ADDENDUM NO. 1 TO PROJECT NO. M3040

**CONSTRUCTION WORK
PROVIDE UTILITY POLES, GROUP CAMP OFFICE
2216 SEVEN LAKES RD. TUXEDO NY**

**BEAR MOUNTAIN STATE PARK
PALISADES INTERSTATE PARK REGION,
ADMIN HDQTRS
BEAR MOUNTAIN, NY 10911**

August 12, 2015

REVISED DETAIL 9 -A1

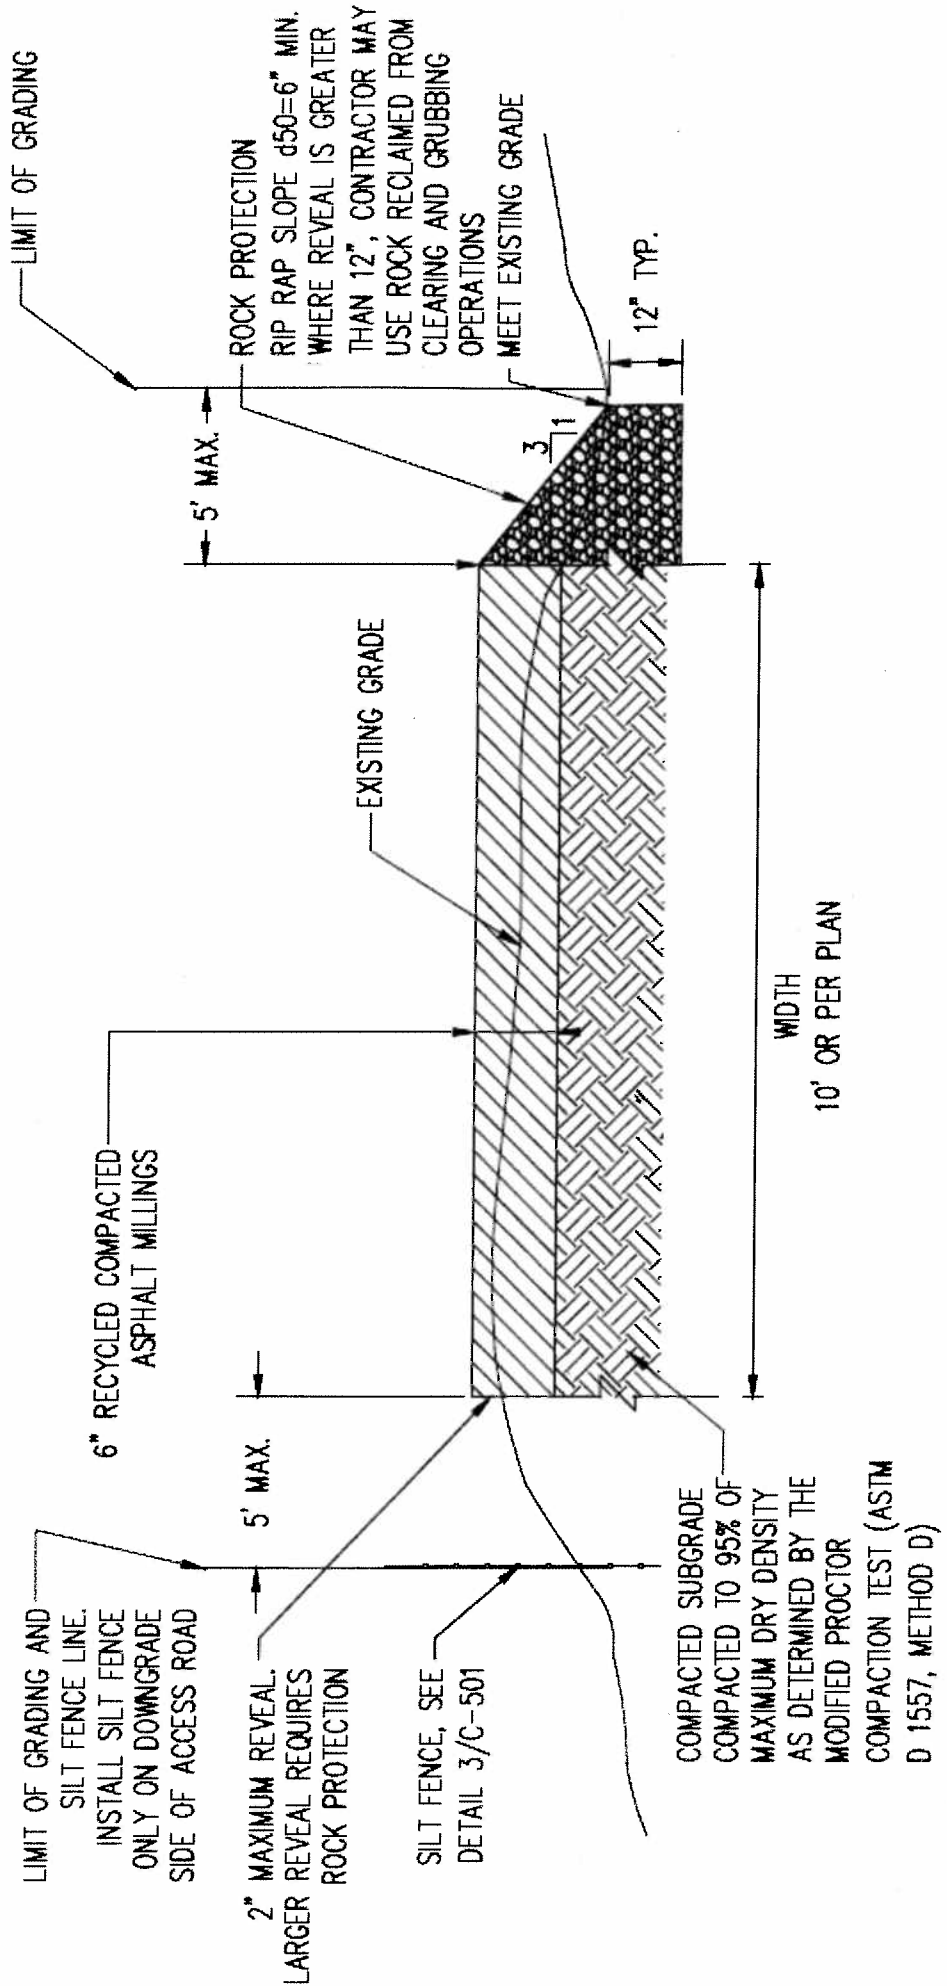
4. DRAWING C-502: Detail 9 - ACCESS ROAD PAVEMENT, ASPHALT PAVING, noted "REVISED DETAIL 9 - A1" accompany this Addendum and supersede the same detail originally issued.
5. DRAWING C-502: Detail 2 - UTILITY POLES, CLASS CHART: Change Class selection from Class 4 to Class 2.

- A. Construct asphalt directly on prepared subgrade. Spread recycled asphalt pavement millings and compact with 10-ton static roller in single lift to the compacted thickness as shown on the Plans.
